**ADDENDUM #2**

**PROJECT** CMHA Rise Center

**DATE** September 6, 2023

**ARCHITECT** MOODY NOLAN, INC.

E1.1 – Addendum 2

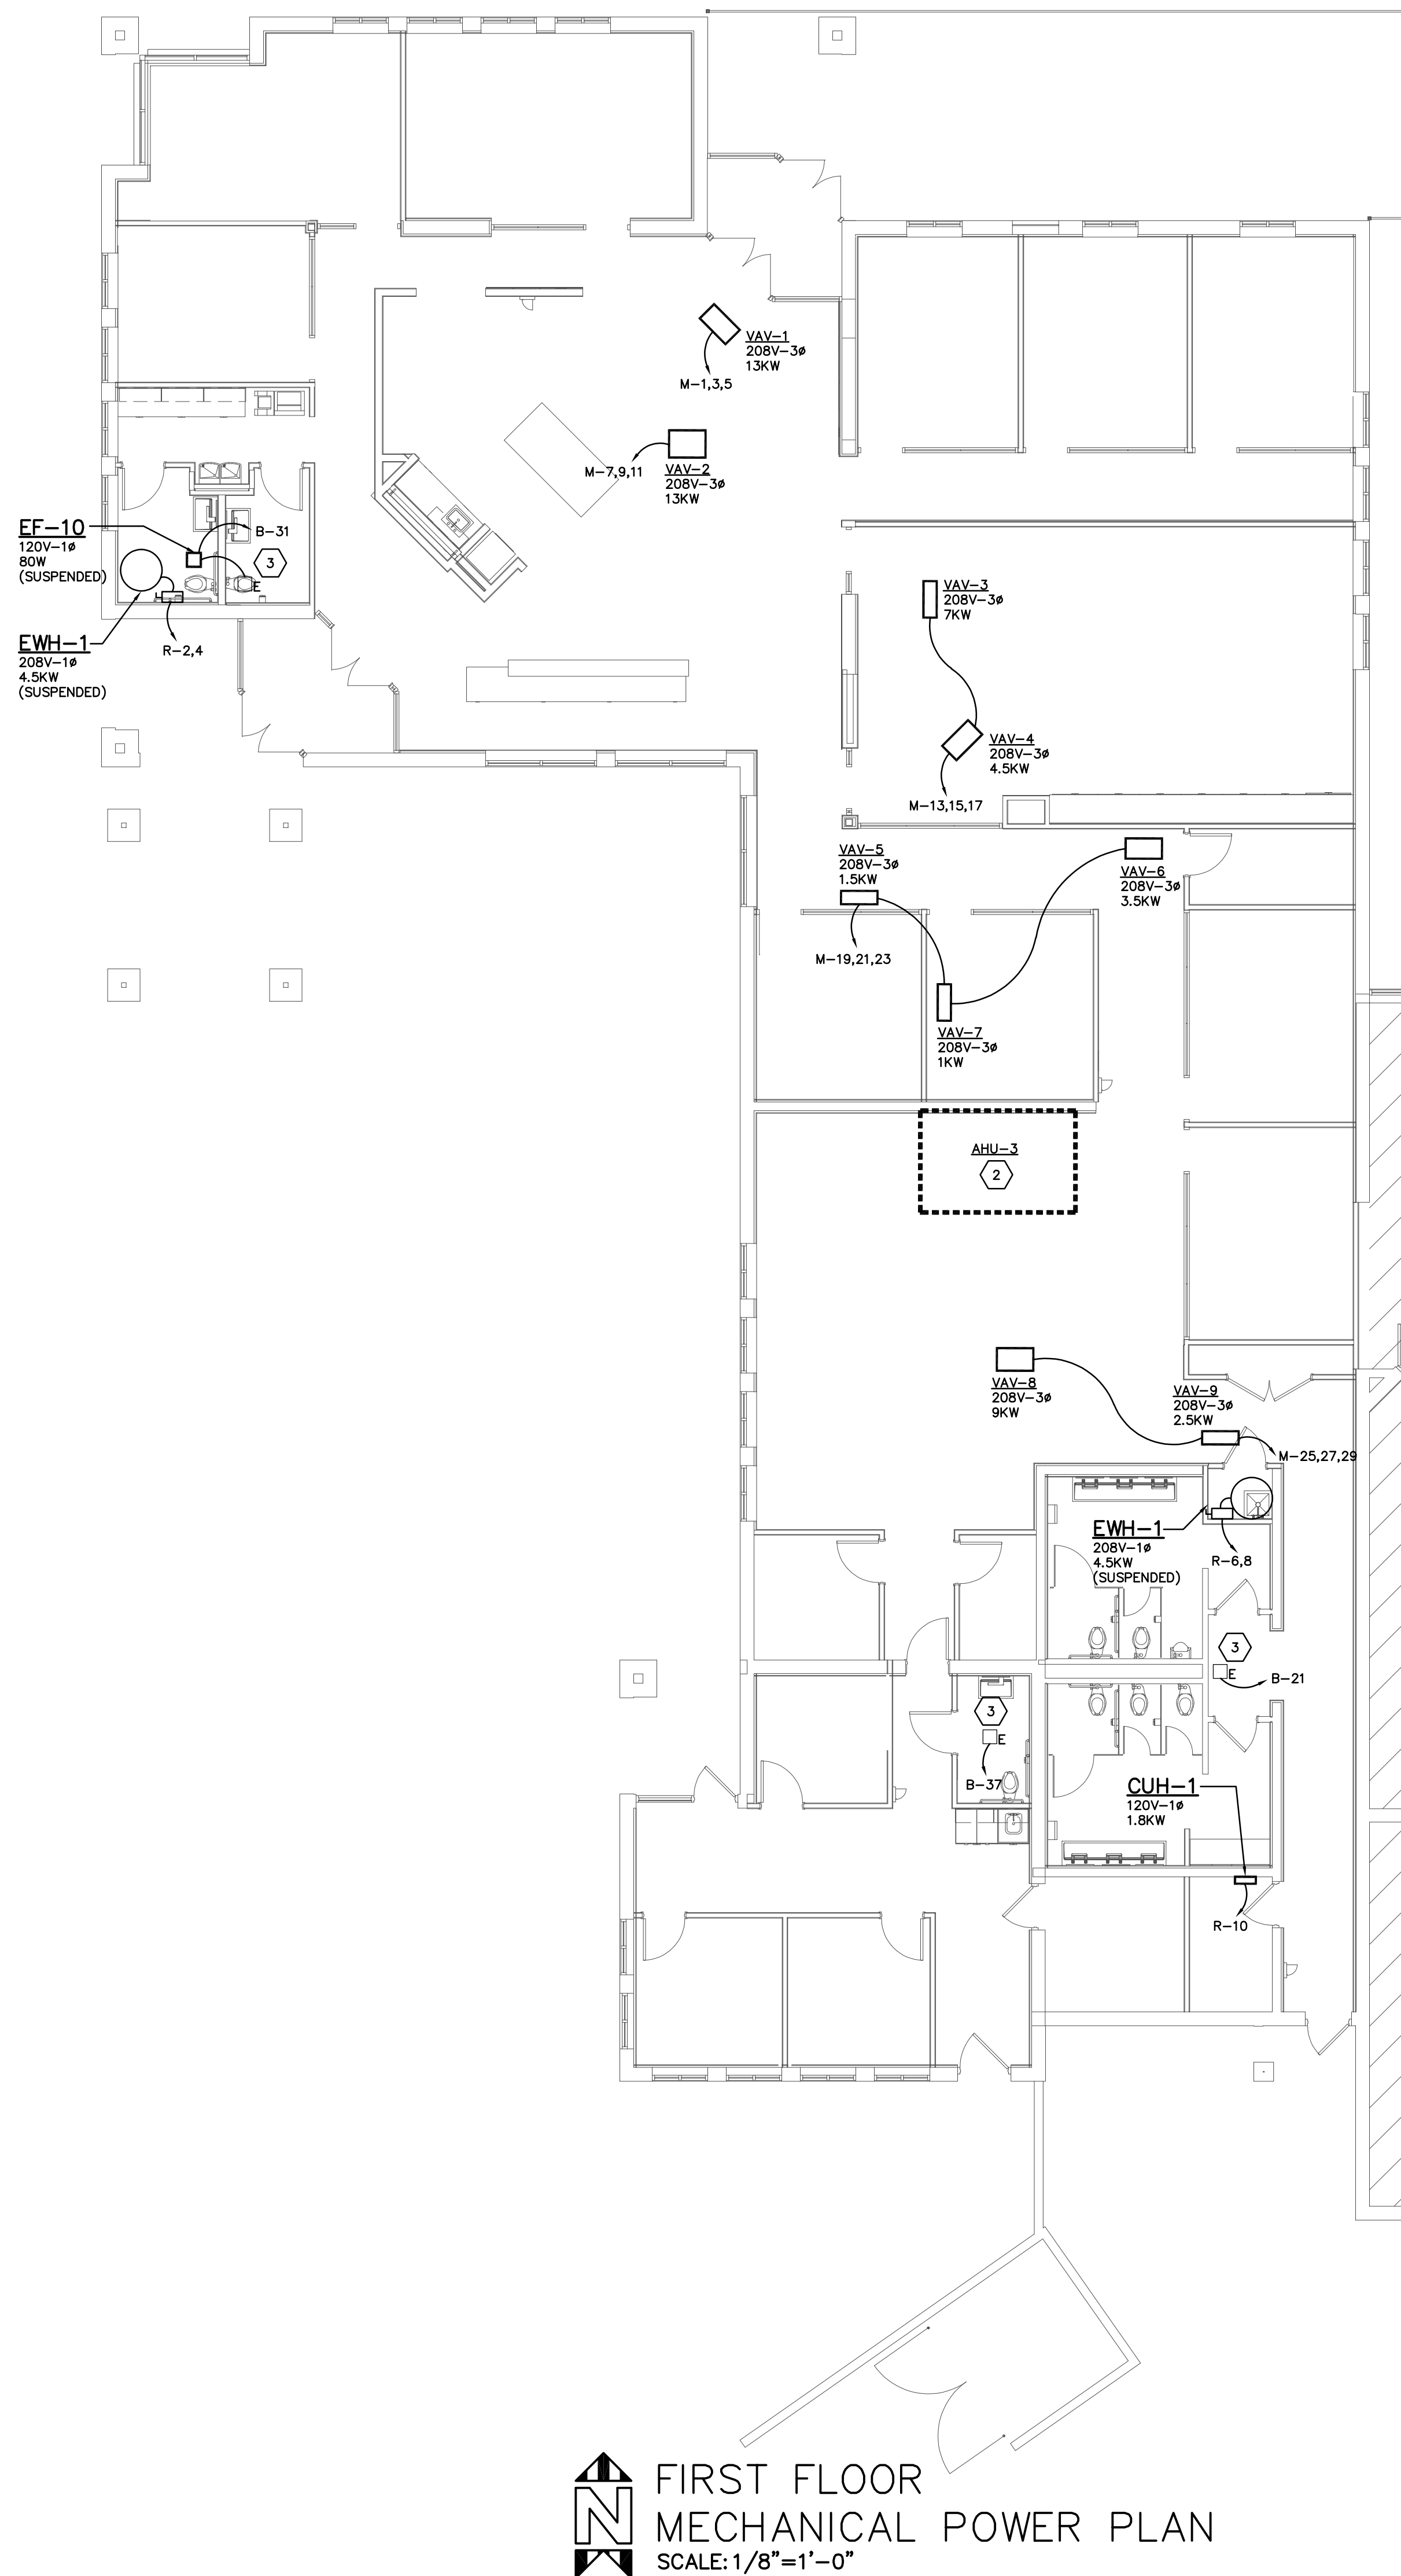
E1.1:

Additional exit signs added.

JULY 18, 2023  
DRAWN BY: PEA CHECKED BY:  
Proj # 22430  
**E1.2**  
100% CD PERMIT

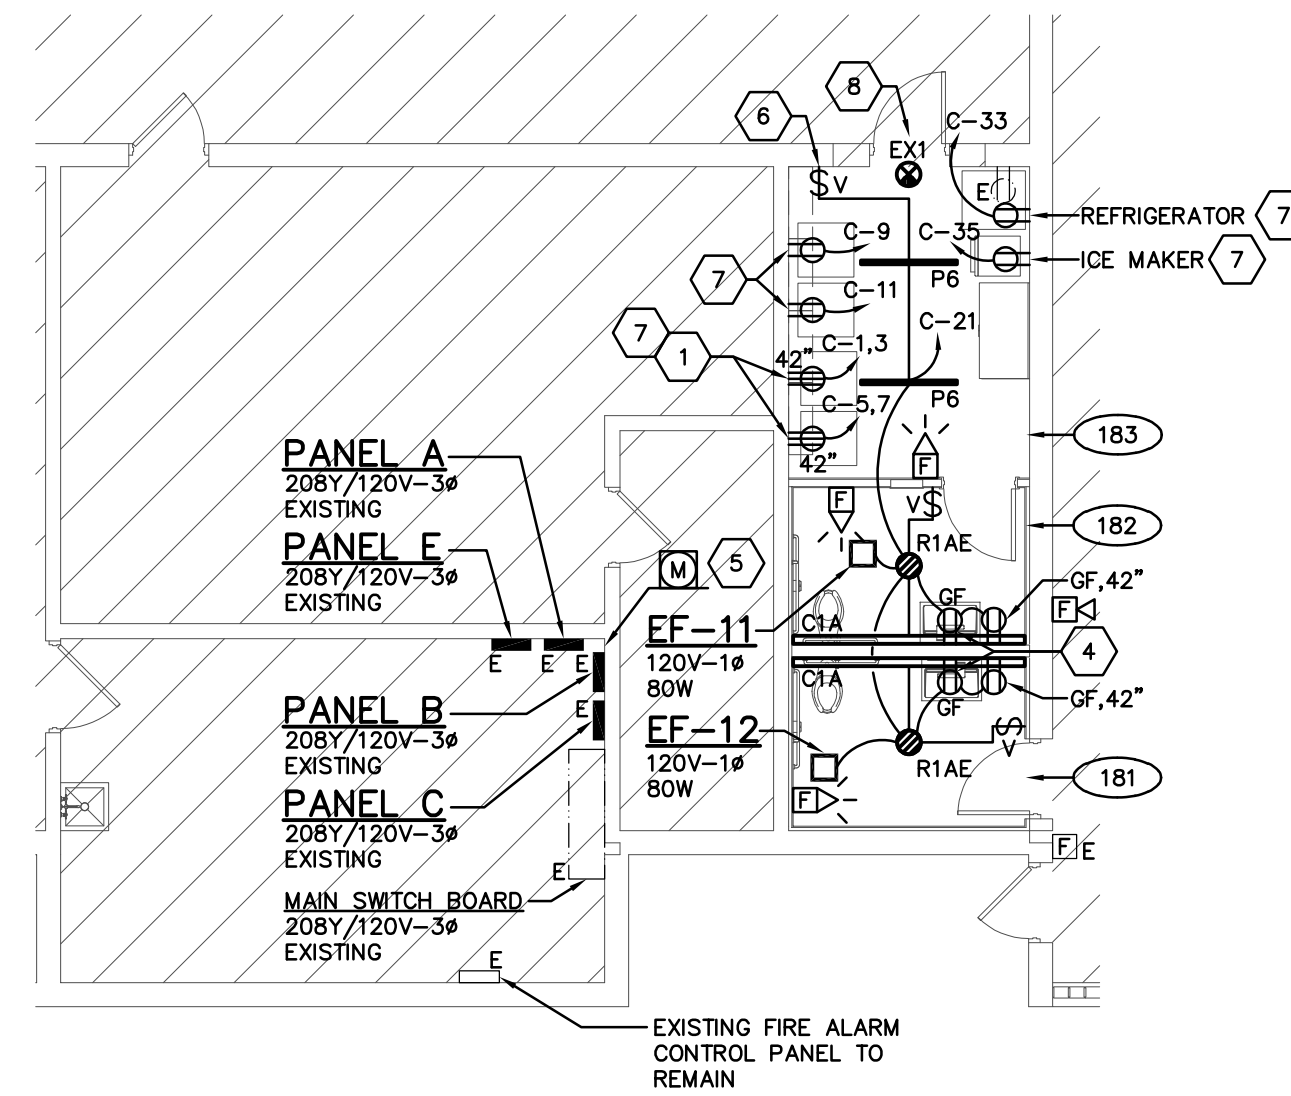
E1.2

General notes and coded notes revised.
